Access Compliance Report

Public Rights-of-Way (Curb Ramps)

Intersection ID: 27315	Main Street: ELM_LN	Cross Street: BALLANTYNE_TRACE_CT	Location: W
ADA ID: 45F355C1804B	Ramp Type: PerpDiag	Initial Pass/Fail: Fail	Overall Compliance: No
Severity Score: 22.5			
Codes/Mitigation Info/Possible Solution		Field Measurements/Component Compliance

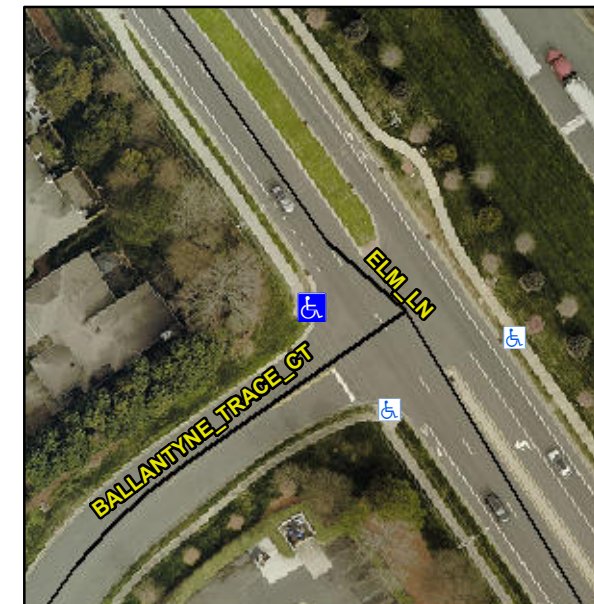
Not Found, R304.5.1, R304.2.2, R304.5.3

Compliance	Description	Data	Compliance	Description	Data
N/A	Ramp Length (in)	47.5	No	Ramp Slope (%)	9.1
No	Ramp Width (in)	46.5	No	Ramp XSlope (%)	4.1
N/A	Flare Type LT	N/A	N/A	Flare Type RT	N/A
N/A	Flare Slope LT (%)	N/A	N/A	Flare Slope RT (%)	N/A
N/A	Flare Traversable LT?	N/A	N/A	Flare Traversable RT?	N/A
N/A	Landing Length (in)	N/A	N/A	DWS Provided?	N/A
N/A	Landing Width (in)	N/A	N/A	DWS Contrast?	N/A
N/A	Landing Slope (%)	N/A	N/A	DWS Length (in)	N/A
N/A	Landing X Slope (%)	N/A	N/A	DWS Full Width?	N/A
N/A	Landing Curb? (Y/N)	N/A	N/A	DWS Offset (in)	N/A
N/A	Shared Landing?	N/A			
N/A	Gutter Ponding?	N/A	N/A	Gutter Slope (%)	N/A
N/A	Gutter Lip Ht (in)	N/A	N/A	Gutter X Slope (%)	N/A
N/A	Painted X Walk1?	No	N/A	Painted X Walk2?	No
	X Walk 1 Direction	To SE		X Walk 2 Direction	To NE
N/A	X Walk 1 Width (in)	N/A	N/A	X Walk 2 Width (in)	N/A
	X Walk 1 Slope (%)	0.4		X Walk 2 Slope (%)	8.0
	X Walk 1 X Slope (%)	6.2		X Walk 2 X Slope (%)	0.7

N/A	Ramp inside XWalk1?	N/A	N/A	Ramp inside XWalk2?	N/A
	Road Slope (%)	1.1	N/A	Clear Space?	N/A
	Road X Slope (%)	6.0	N/A	Clear Space to XWalk (in)	N/A
N/A	Any Obstructions?	N/A	N/A	Storm Grate/Utility Hazard?	N/A
	Obstruction Type			Storm Grate/Utility Type	
		N/A			N/A
			Yes	Surface Condition? (G/P)	Good

Remove & Replace Curb Ramp With Two New Directional Ramps or Equivalent.
